January 30, 1998

RE: Information Needed for Case Closure
Former Hiro's Nursery, 1630 162nd Ave., San Leandro (our site # 1361)

Environetics Geo-Engineering		HIRO'S NURSERY, INC. 1630 162nd AVENUE, SAN LEANDRO, CA 94578 SITE MAP		FIGURE 3
Project No.: 70721	Drawn by: V. N. C.			
Date: 10/15/92	Checked by: J. P. B.

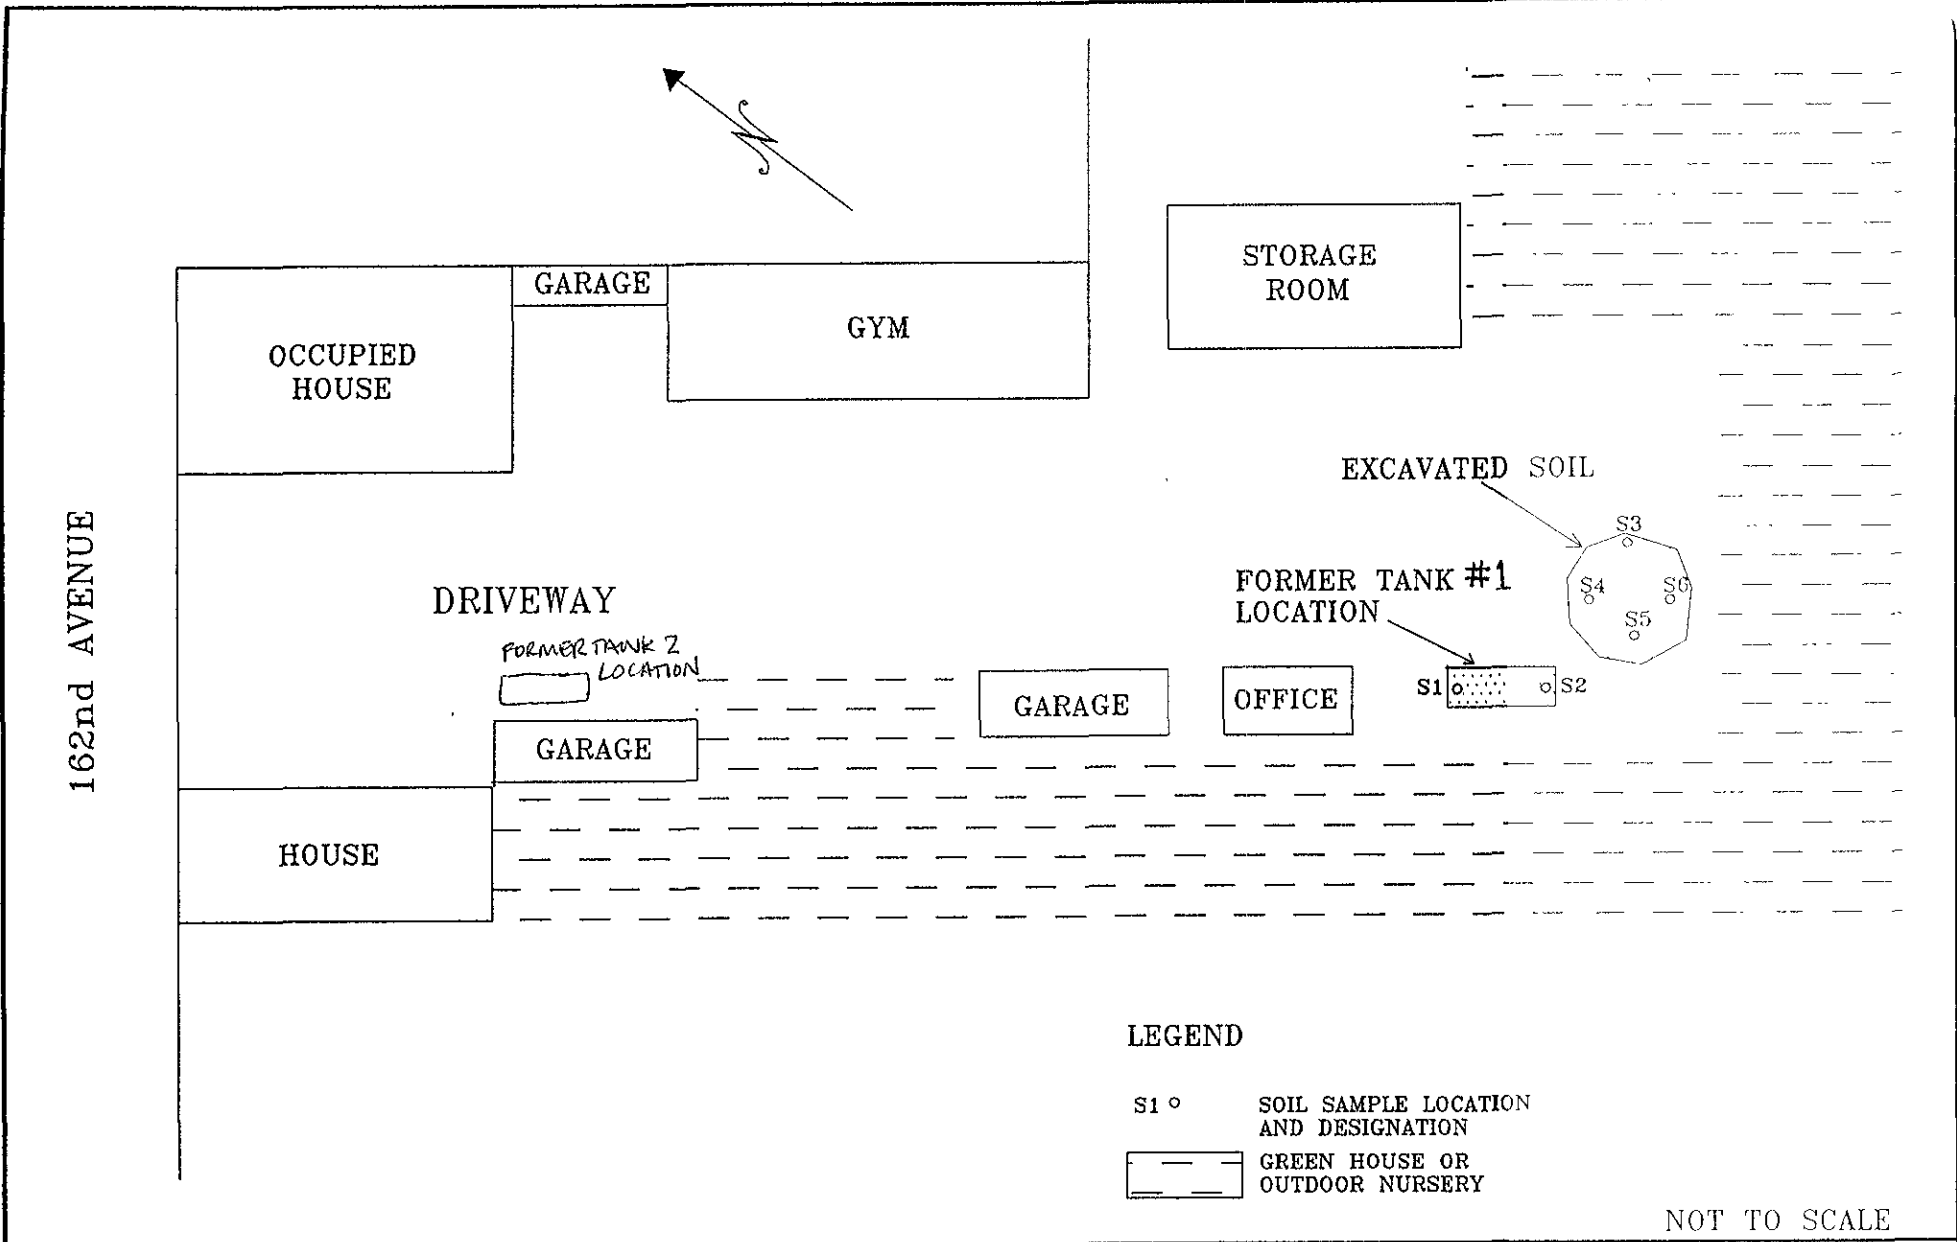
- 1) The file contains a site diagram that is not attached to or explained by any report from your consultants. This diagram contains handwritten notes listing high petroleum contaminant levels. I do not know the date or origin of this information. Can you provide information about this document? A copy of the diagram is enclosed.

- 2) What is the current use and configuration of the property? Are the residences that existed in the early 90's still onsite? Have any new residences or other buildings been constructed there? If so, where are the new buildings situated on the property? This information is especially relevant if the benzene levels described on the diagram referred to above remain at the site.

From Kaufman + Braackis
1989 Study
per Mr. Nukushima
3/3/98
OK

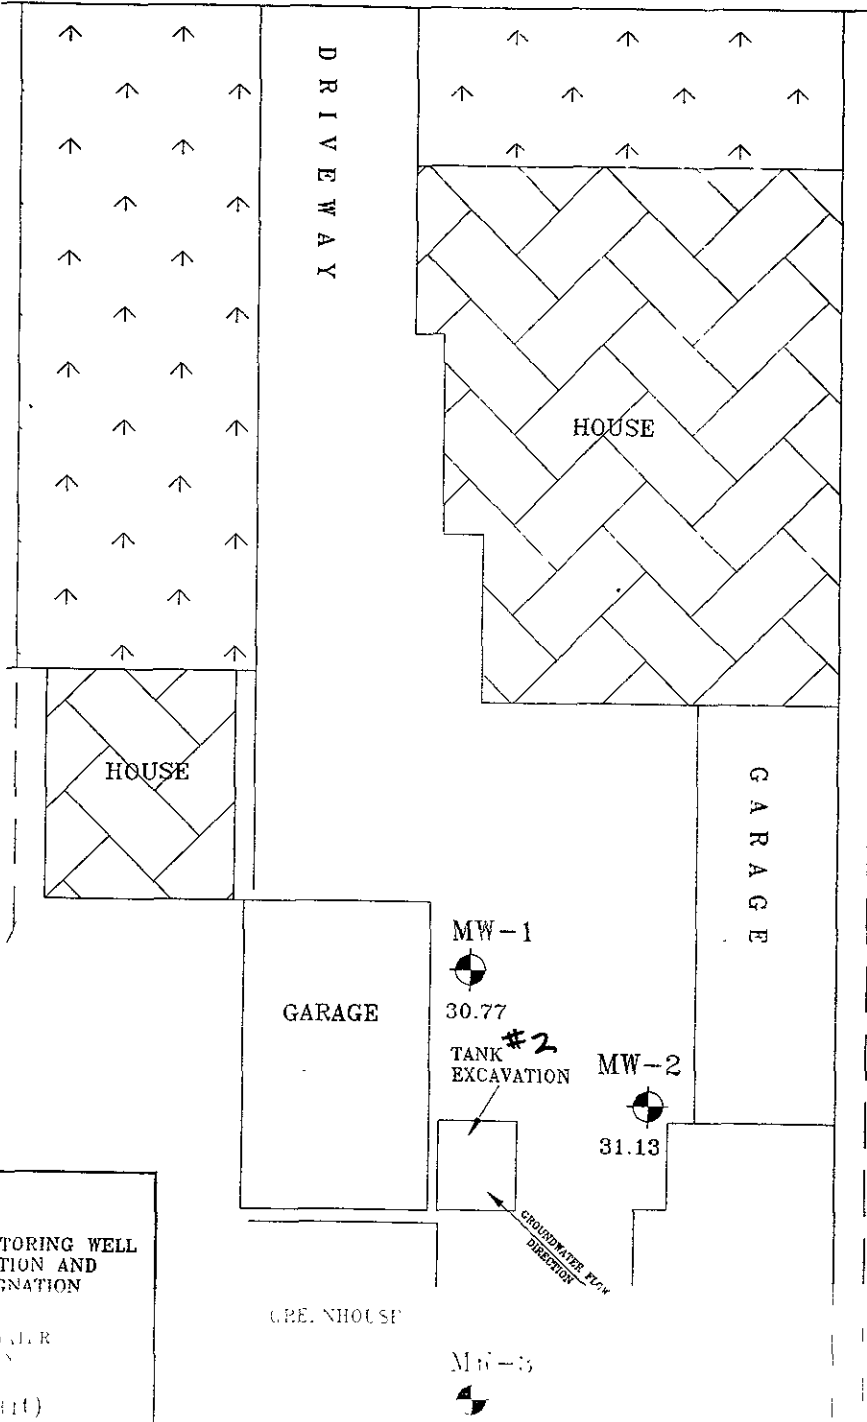
- 3) Other "tanks" besides the removed fuel tanks are shown in site diagrams in your file. I suspect that these are (or were) above ground pesticide mix or other storage tanks. A diagram is enclosed. Can you tell me more about these tanks?
